Montgomery Planning  
**2115 EAST JEFFERSON STREET**  
**PRELIMINARY PLAN NO. 120230100**  
**SITE PLAN NO. 820230080**  
**FOREST CONSERVATION PLAN NO. F20230220**

Nos. 120230100, 820230080 &  
F20230220  
Completed: 10-2-2023

MCPB  
Item No.  
10-12-2023

Figure 12 – Private Street B With On-Street Parking At Front Loaded Townhouses Cross-Section

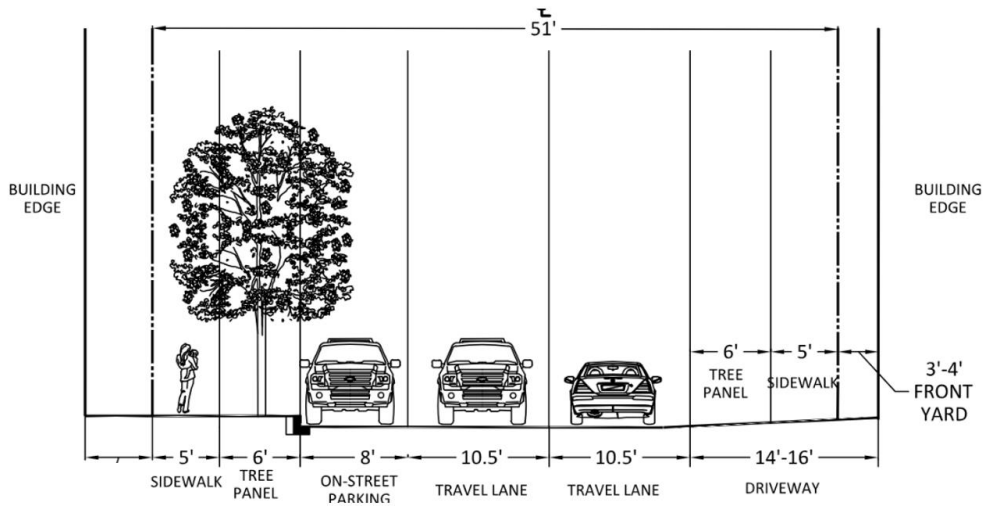
Change the title of Private Street B Section without Parking at Front Load Townhouses to Private Street B Section With Parking at Front Load Townhouses and modify the figure to have – 5-foot-wide sidewalks, 8-foot-wide on-street parking, 10.5-foot-wide travel lanes

Figure 13 – Private Street C Cross-Section

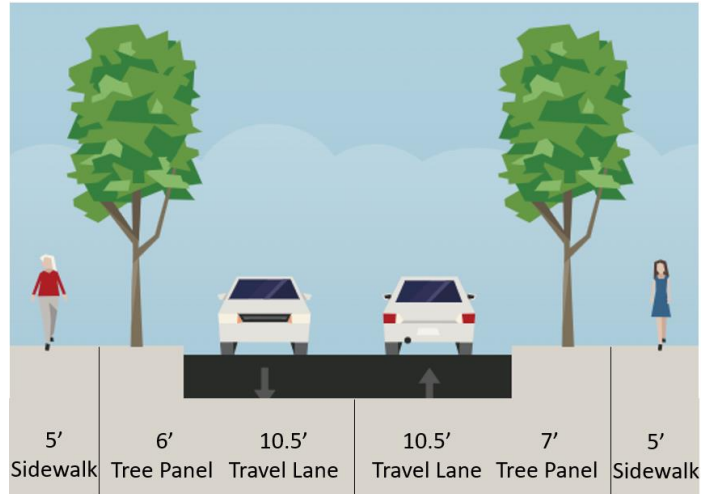
- Private Street C – remove the 11.5-foot-wide tree panel and replace with a 7-foot-wide tree panel and 5-foot-wide sidewalk
- g) Show the bus shelter and bench per MCDOT letter.
